Bulletin | Danfoss Turbocor Compressors

# Customer Notification

B-CN-037-EN REV A

**SUBJECT:** Motor & Electronics Cooling Solenoid Actuator Coil Markings

Figure 1 - Blue Mark

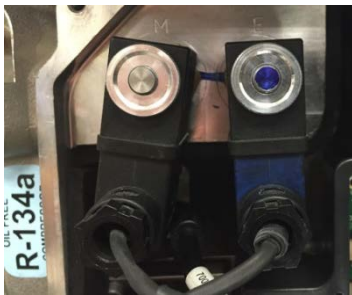
To assist in the proper placement of solenoids, the right side solenoid stem and actuator coil were marked "blue" to distinguish them from the left side solenoid and stem which is shown in Figure 1. A change has been made that incorporates the use of a label to distinguish between the left ("L") and right ("R") actuator coils.
